MODIFICATION #6
WEST LILAC ROAD (EAST OF EASTERLY ROUNDABOUT)

Request for a
Modification to a Road Standard
and/or to Project Conditions

Project Number: TM 5571/5572 Date of Request: January 31, 2014

ATTACHMENT 1

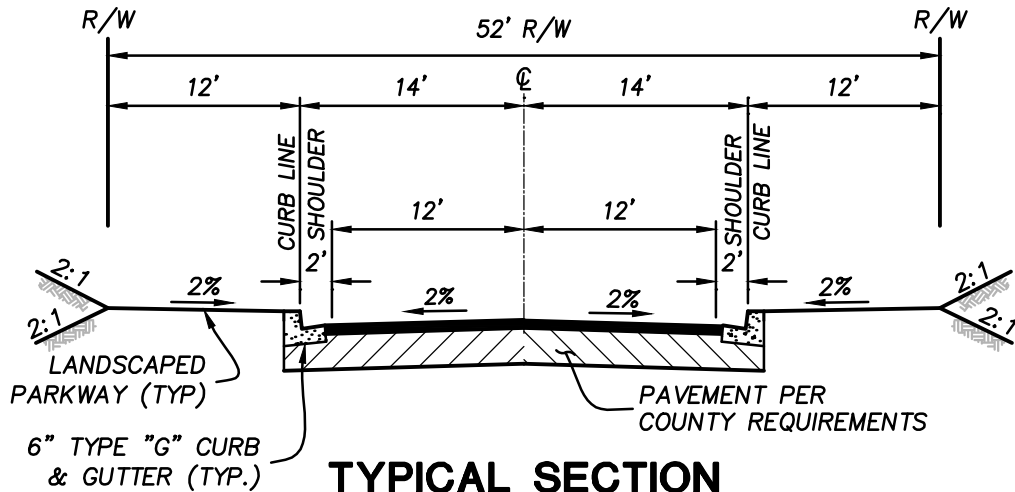
The requested road modification pertains to exist W. Lilac Road, East of the proposed
Easterly roundabout. There is no existing right-of-way for West Lilac Road. Existing W.
Lilac Road in this area has a pavement width of 20'-24' wide see (Attachment 1). The request
is to improve the Southerly portion of the road (plus 12' additional pavement on the North)
within the project boundary and within the prescriptive rights the public has to existing
West Lilac Road to current County standard 2.2F so that we can keep the disturbance to adjacent
property owners to a minimum. This will also allow us to transition to the existing pavement
of West Lilac Road east of the project boundary without condemning additional offsite
right-of-way and disrupting existing access points to adjacent properties.

LILAC HILLS RANCH 2.2F LIGHT COLLECTOR MODIFICATION TO ROAD STANDARDS

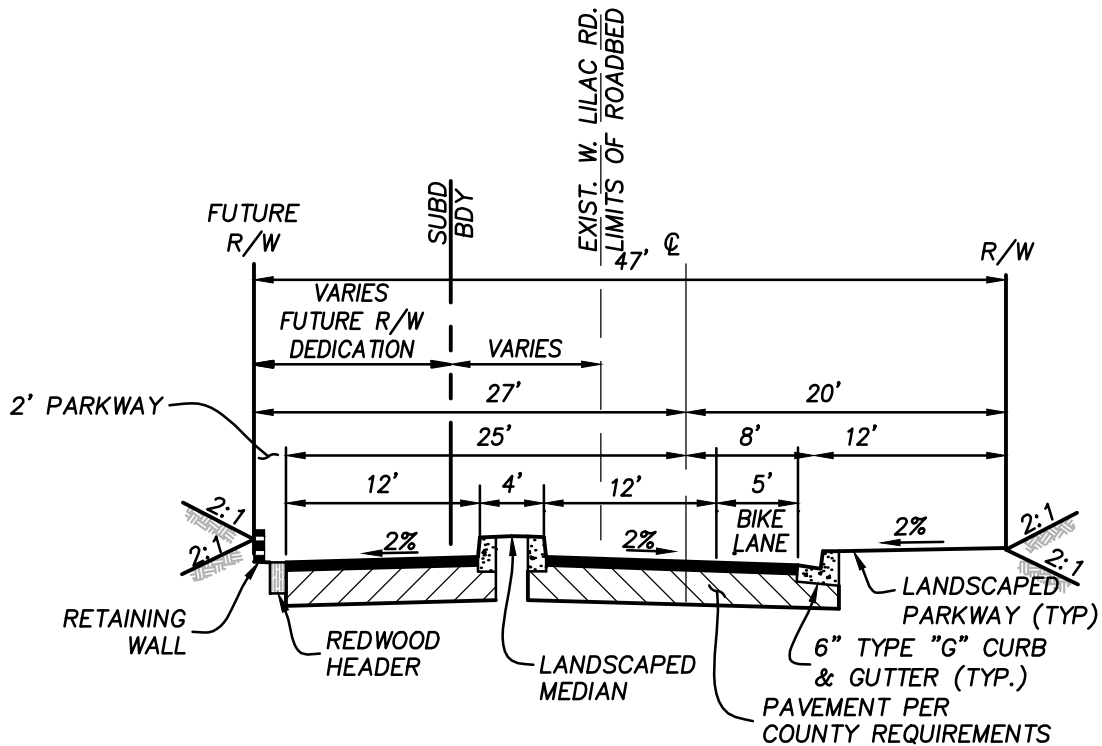
The standard road section for Light Collector 2.2F requires 28' road surfacing width,
52' ROW, 2' shoulder, and 12' parkway. We propose to improve this roundabout approach with a 4'
splitter island and 12' travel lane, 5' bike lane and full 12' pkwy along south and 12' travel lane
and no shoulder and reduced 2' pkwy along the north.

**ATTACHMENT 2
WITH MODIFICATION #6
LILAC HILLS RANCH: 2.2F LIGHT COLLECTOR**

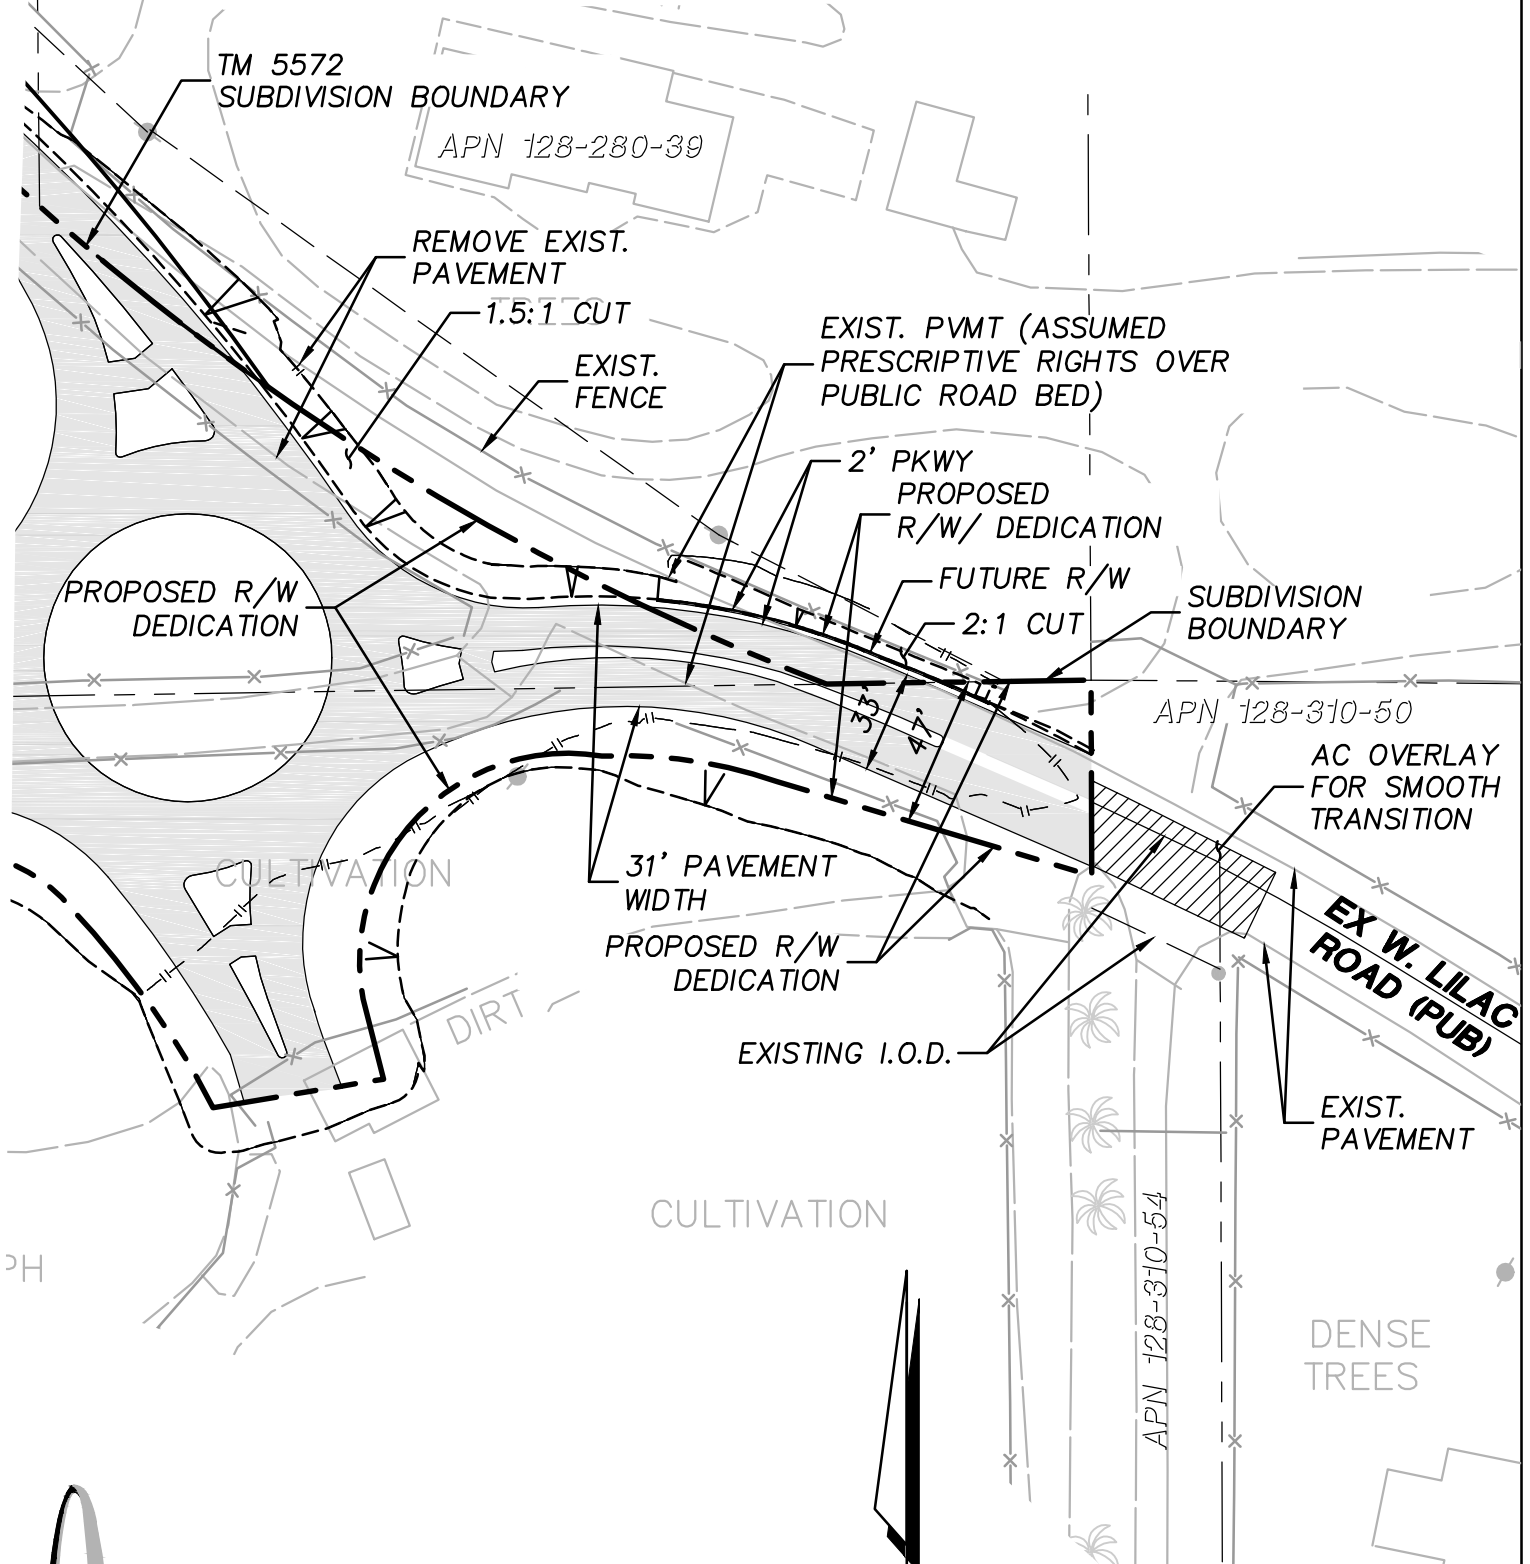
To improve West Lilac Road to full width 2.2F County Road Standards will
require widening and additional right-of-way. This will result in tremendous disruptions
to adjacent home owners that use this road & would require us to obtain offsite permission
to grade and right-of-way from hostile neighbors. In addition, the proposed modification
is preferred with regards to appropriate roundabout approach design.

See Attachment 2 for road design with modification.

ATTACHMENT 3 WITHOUT MODIFICATION #6 WEST LILAC ROAD

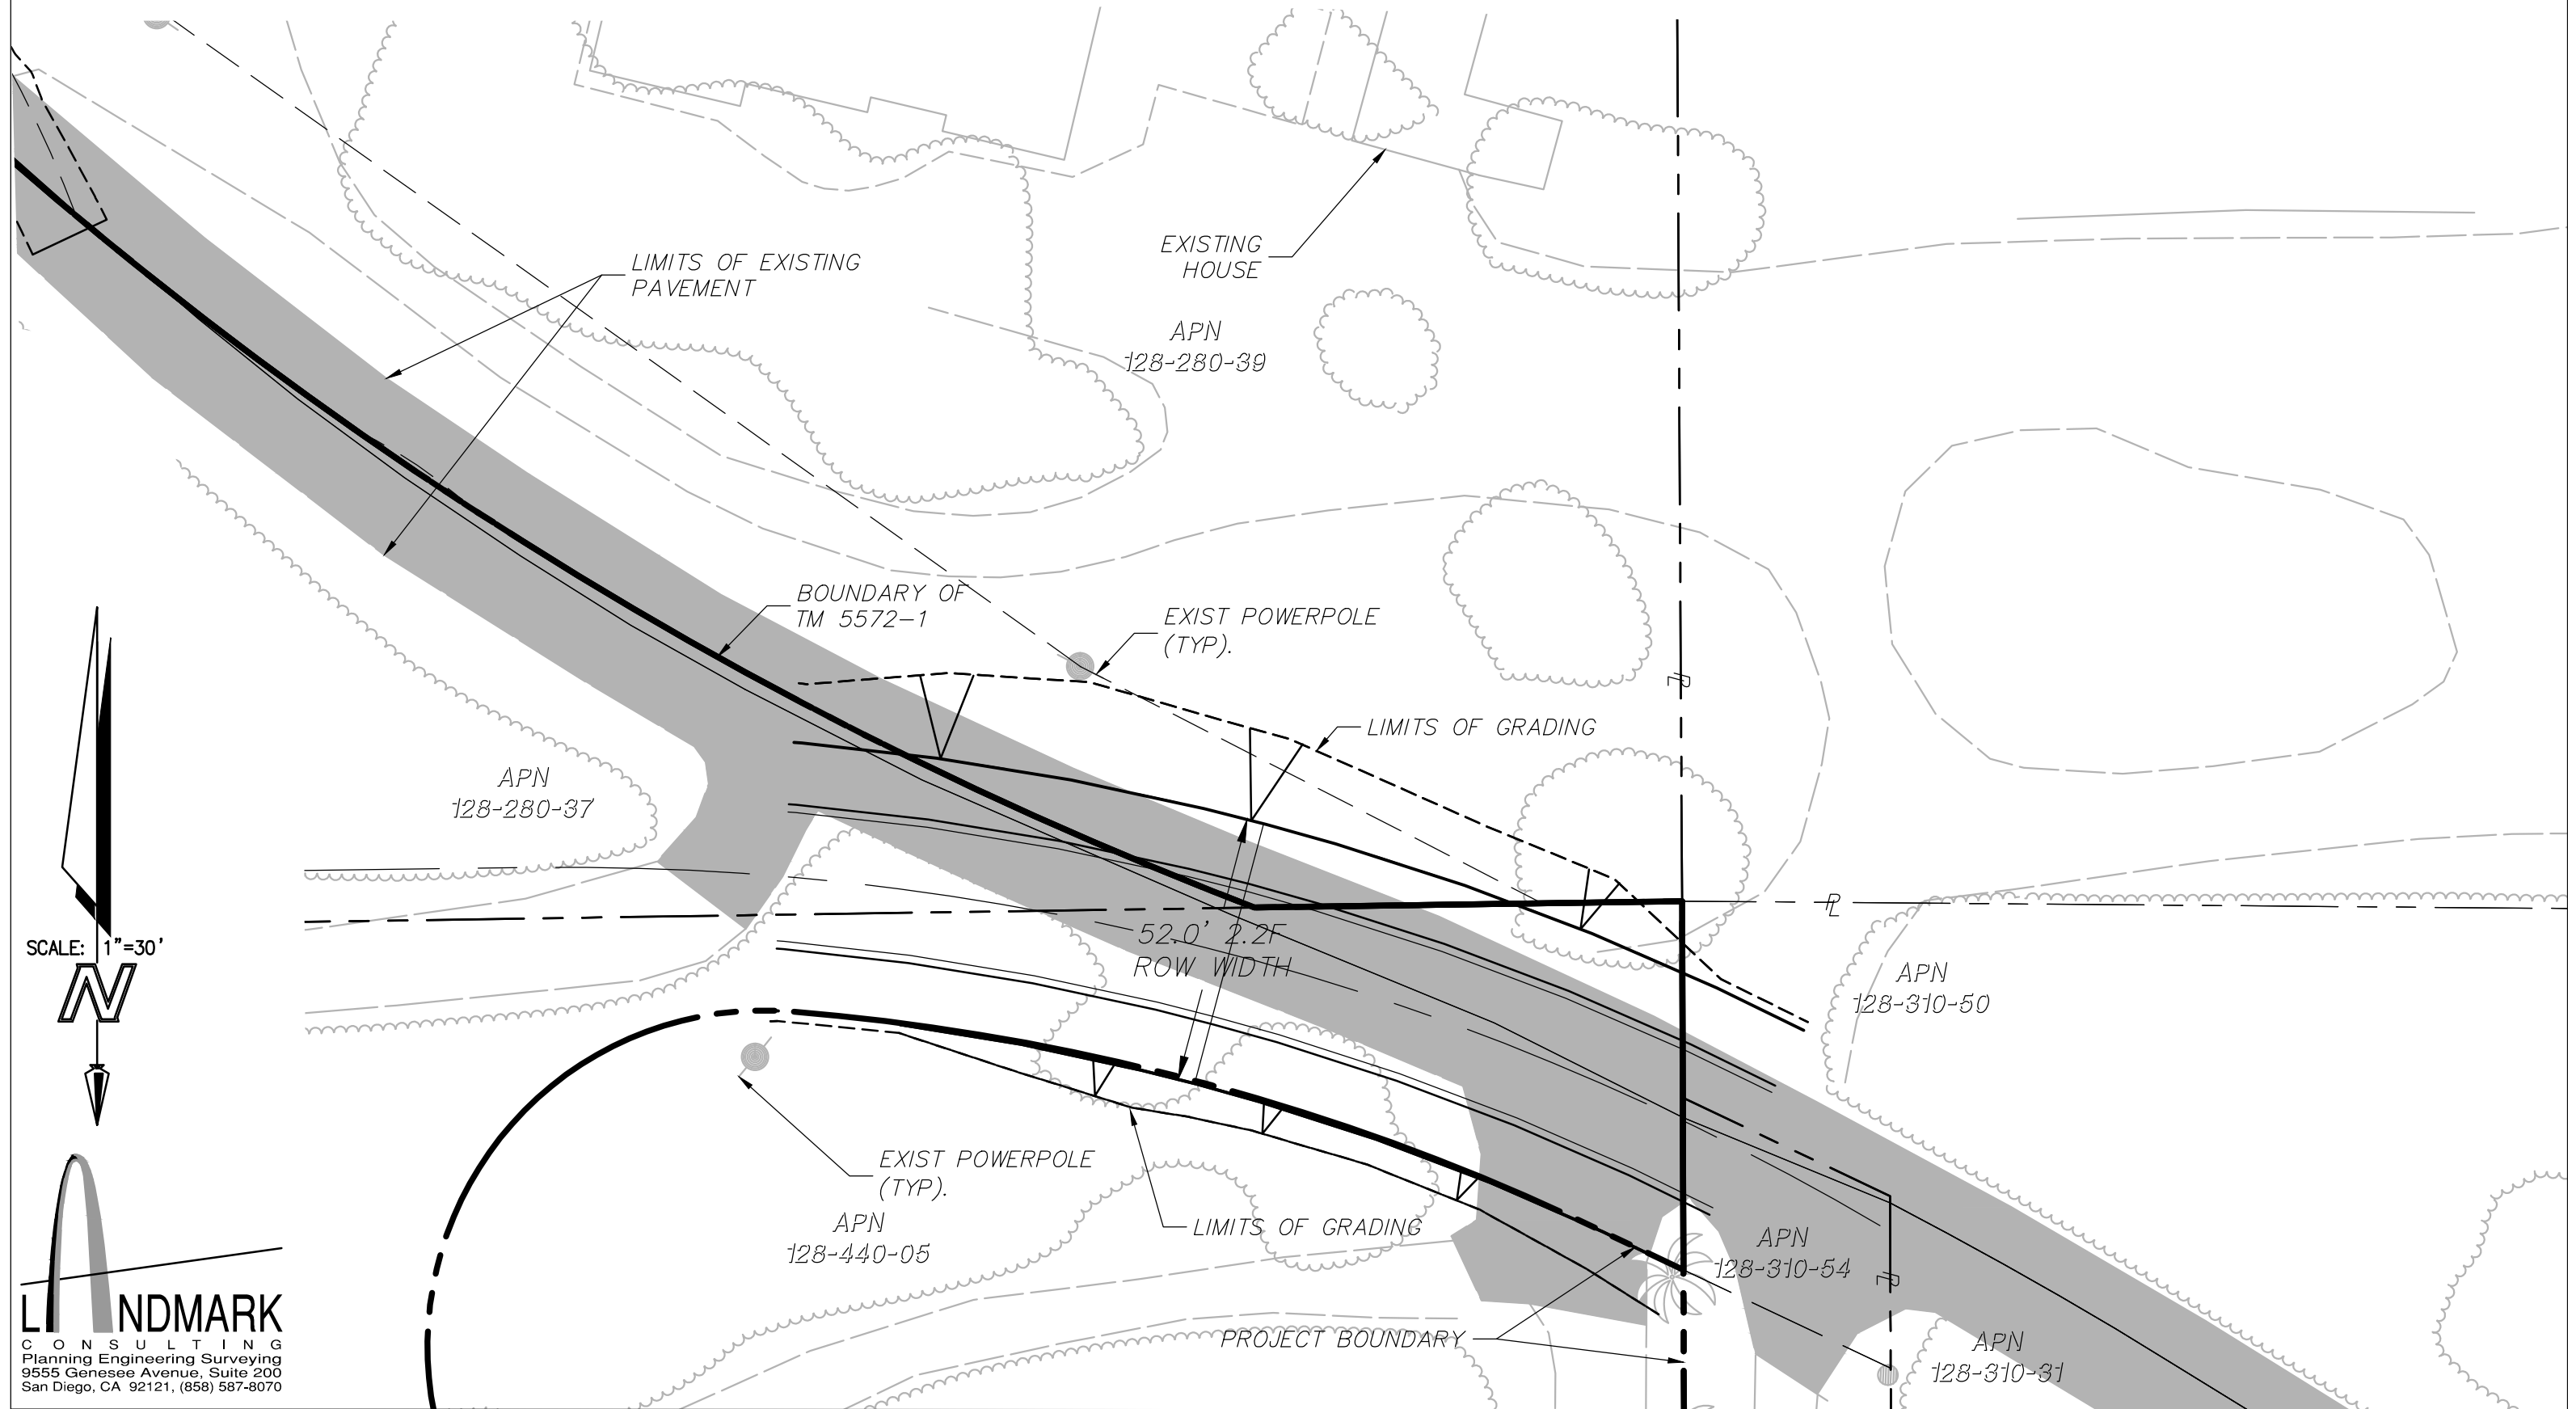
List alternatives that could mitigate the requested Modification (attach engineering sketches showing proposed layouts, details and notes): Widen the road to public road standards.

See Attachment 3 for road design without modification.
